Gazcorp Industrial Estate Modification 1

Amendments to Concept Plan and Stage 1 DA Earthworks

State Significant Development Modification Assessment (SSD-5248 MOD 1)

December 2021

Figure 7 | Sensitive receivers identified in the NVIA

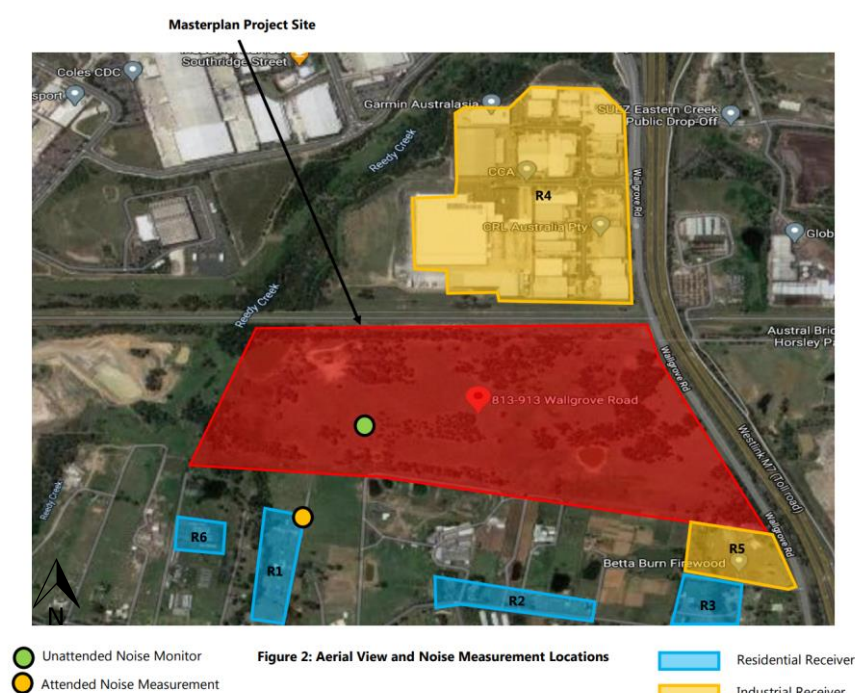
The Department sought clarification from the Applicant regarding the unattended noise monitoring undertaken within the subject site (see **Figure 7**) as it appears to have been influenced by extraneous noise indicated by higher ambient and background noise levels during the night than the day. The NVIA shows the unattended noise monitoring location was not at the most-affected residential receivers rather was within the site. The Department thereby raised concern this was not likely to provide background noise levels that are representative at the most-affected residential receivers to appropriately derive intrusiveness and sleep disturbance noise criteria in accordance with the NPfI. Further, the Department found the NVIA to be unclear on how the reversing swept paths associated with the revised Concept Plan and the corresponding operational noise generating activities have been accurately modelled. The Department met with the Applicant to discuss these issues.

The Applicant submitted a Supplementary RtS responding to the Department's concerns. The Supplementary RtS included suggested amendments to Condition A13 of the SSD-5248 development consent, which provides operation noise limits for Concept Plan but did not include an updated NVIA.

Figure 8 | Location of the Proposed Noise Wall to the south of warehouse building 10

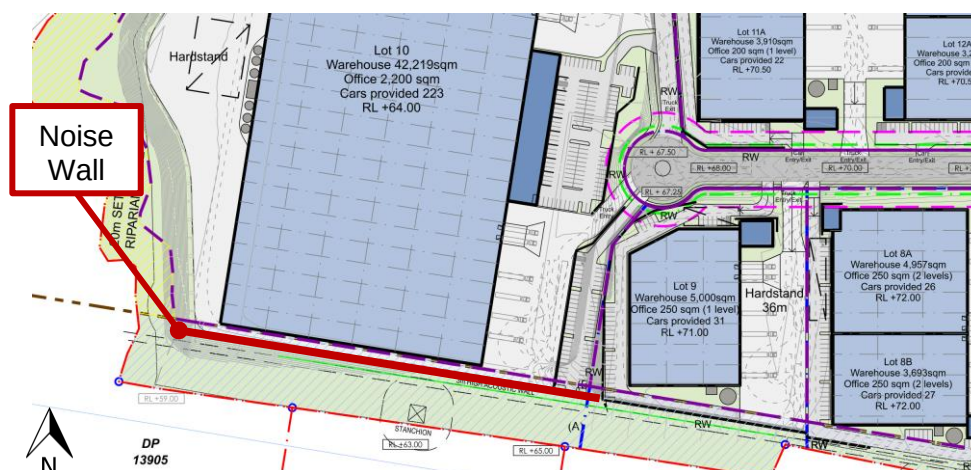
The NVIA noted that compliance with PNTLs would be contingent on noise emission from mechanical plant being effectively insulated and a range of mitigation and management measures implemented. These measures include restricting heavy vehicle exhaust brakes and where practical, ensuring heavy vehicles are switched off once they have arrived at the loading dock and limiting the discharge of airbrake compressors. Additionally, warehouses along the southern boundary are required to be constructed with acoustically insulated roofs and walls. The construction of a 3 m high noise wall to the south of warehouse building 10 as part of the approved development (see **Figure 8**) is also required to mitigate operational noise of the amended Concept Plan.
